**NEBRASKA ARMY NATIONAL GUARD
1776 READINESS CENTER
DEDICATED OUTSIDE AIR SYSTEM (DOAS)**
at the

PROJECT NO. 31030365

A D D E N D U M N O . 1

DRAWING TITLE:
 ADDENDUM #1 -
 ATTACHMENT #4
 REF. SHEET NO.:
A196
 01/31/2024

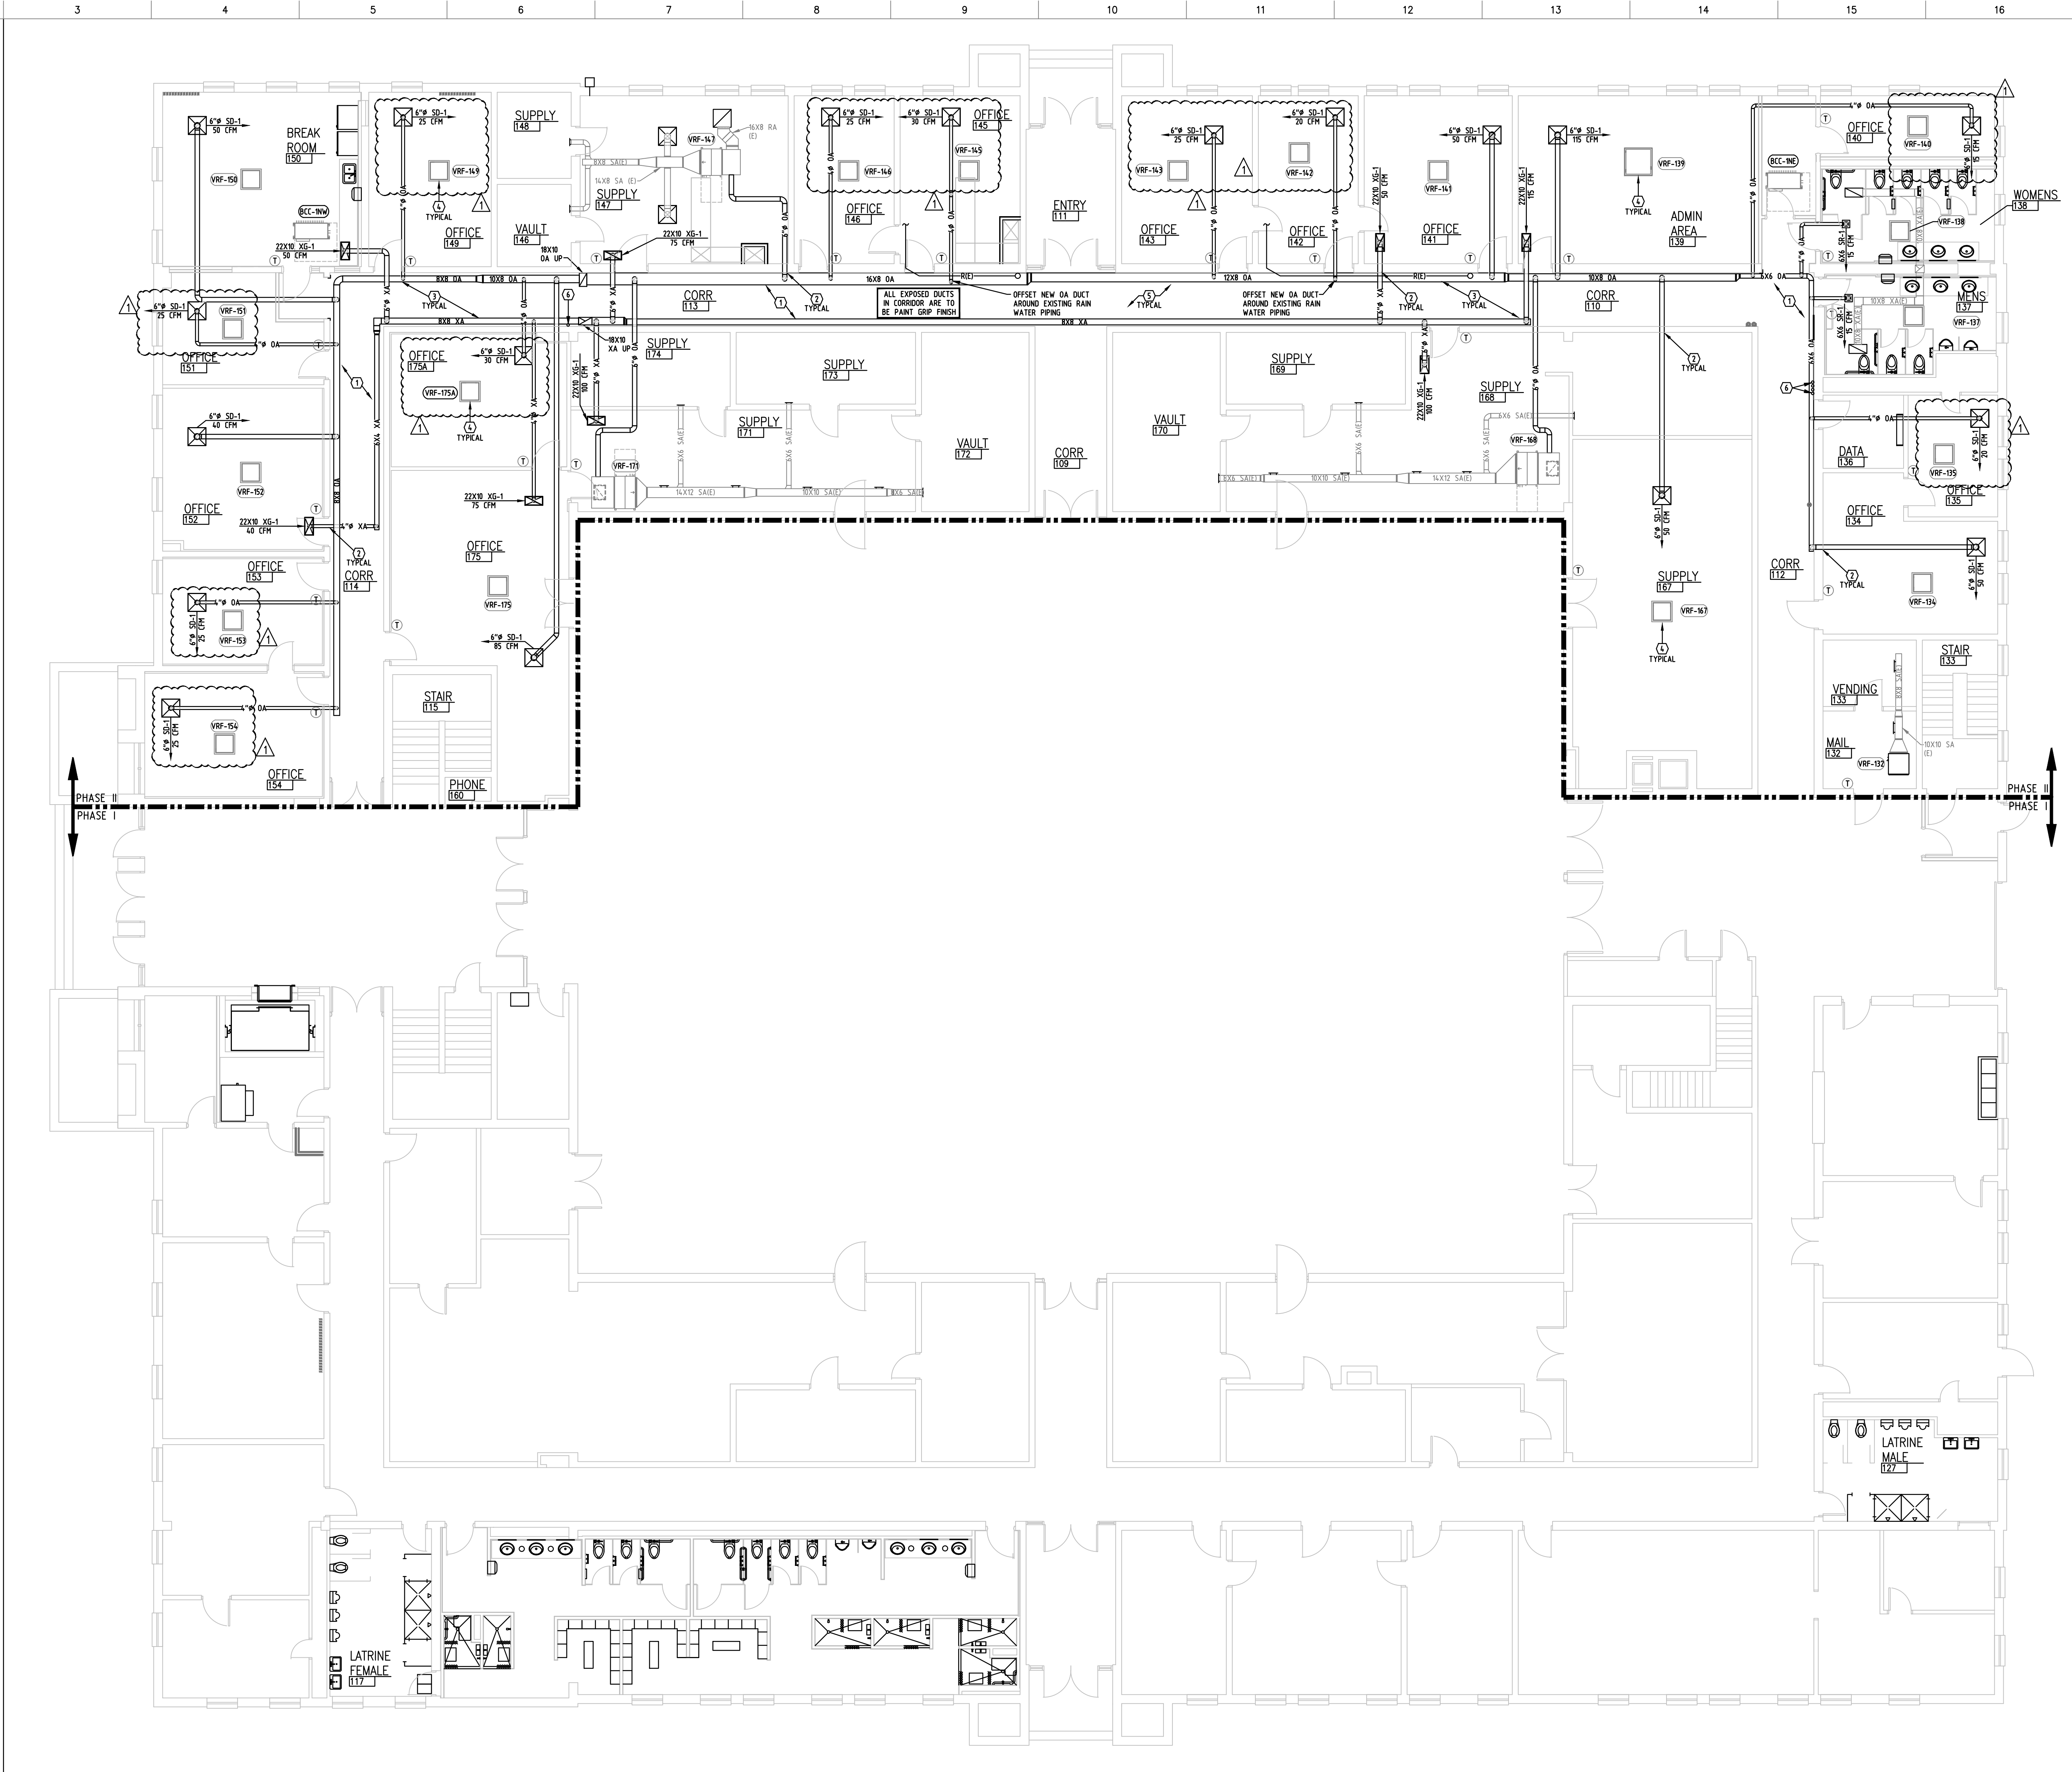
- ADD 1-6 Reference Sheet D196
1. Detail A1, Roof Plan – Demolition, NW Corner of Roof
 - a. Add – Remove existing exhaust fan and curb. See attachment #4.

- ADD 1-7 Reference Sheet A196
1. Detail A1, Roof Plan, NW Corner of Roof
 - a. Add – Patch plywood roof deck, insulation and EPDM membrane to match existing. Apply silicone reflective coating. See attachment #4.

- ADD 1-8 Reference Sheet MD300
1. Detail C3, HVAC Demo Plan - Roof Plan, NW Corner of Roof
 - a. Add – Remove existing exhaust fan and duct in ceiling. See attachment #4.

- 02.01 REMOVE EXISTING EXHAUST FAN & DUCT IN CEILING.
 A. REMOVE EXISTING EXHAUST FAN, DUCT, AND CURB.
 B. DISCONNECT CONDUCTOR AND REMOVE FROM CIRCUIT PANEL.
 C. PATCH PLYWOOD ROOF DECK.
 D. PATCH ROOF INSULATION MEMBRANE.
 E. APPLY SILICONE REFLECTIVE COATING.

DRAWING TITLE:
FIRST LEVEL HVAC FLOOR PLAN

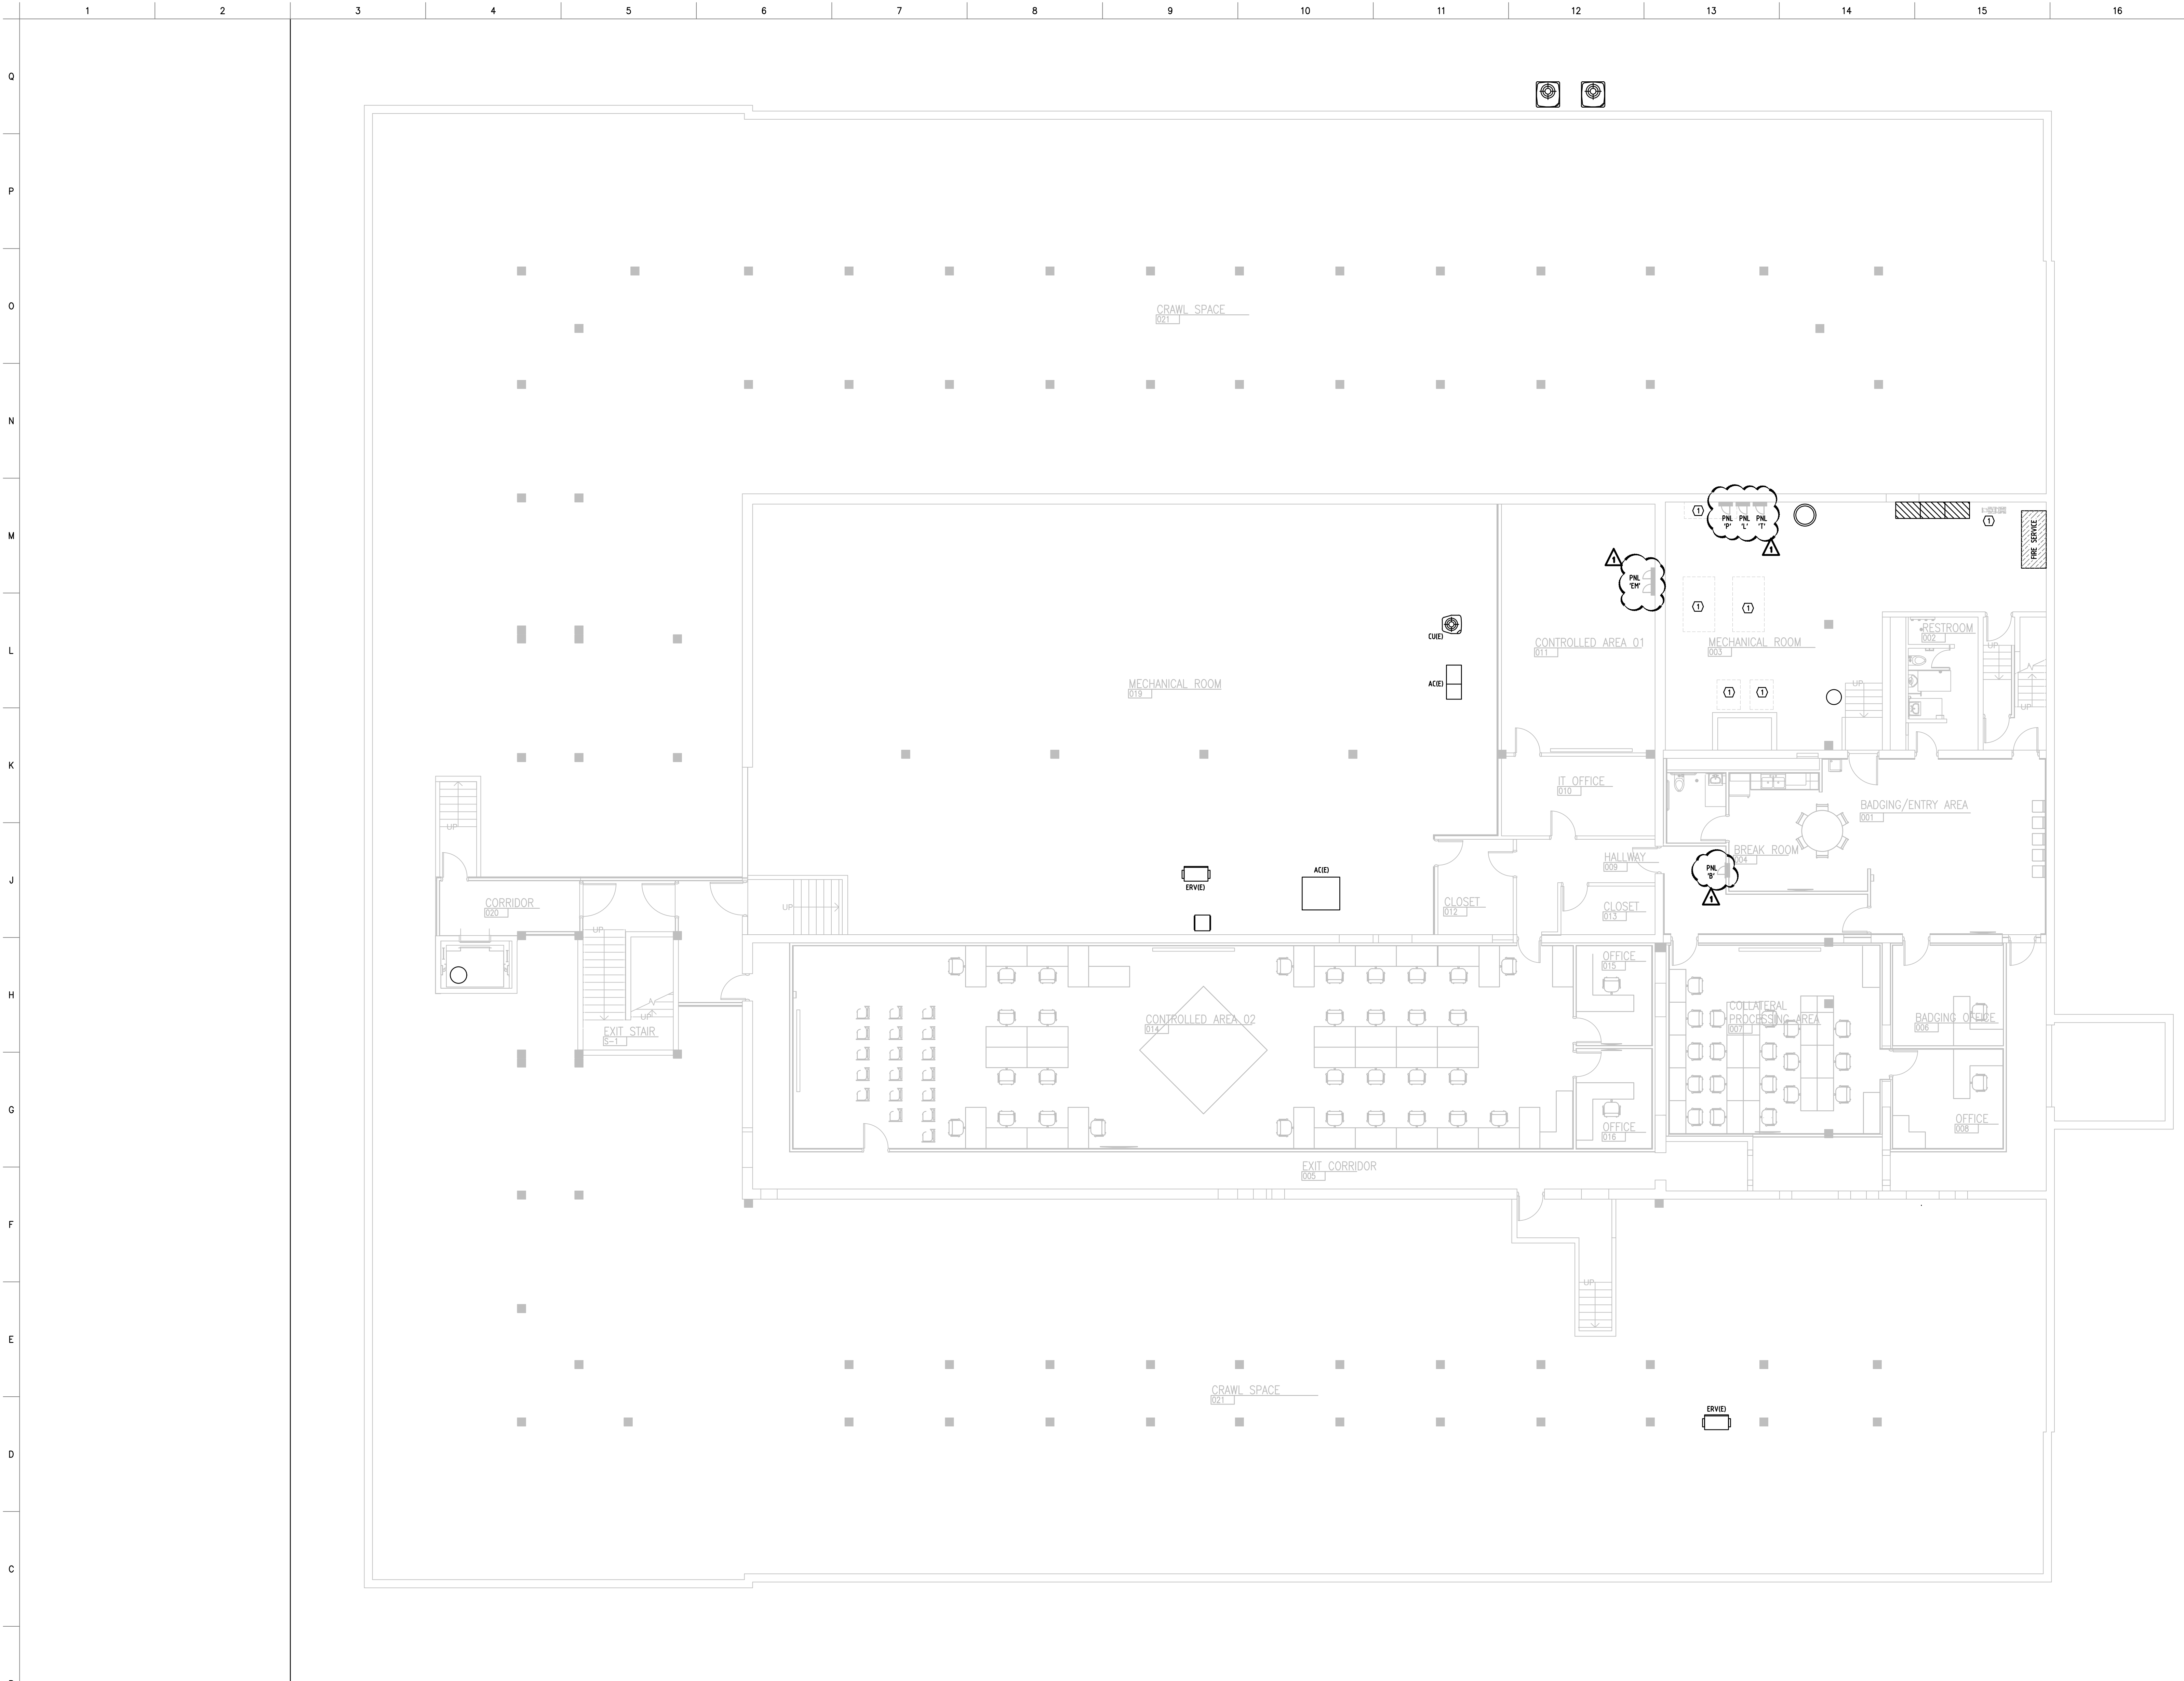
- ADD 1-9 Reference Sheets M100 and M200
1. See attached revised sheets indicating revised ductwork, diffusers, registers, and grilles. Outside air ductwork from dedicated outdoor air system (DOAS) shall be ducted to supply air diffusers in lieu of directly to the variable refrigerant flow (VRF) cassettes. See attachment #5.
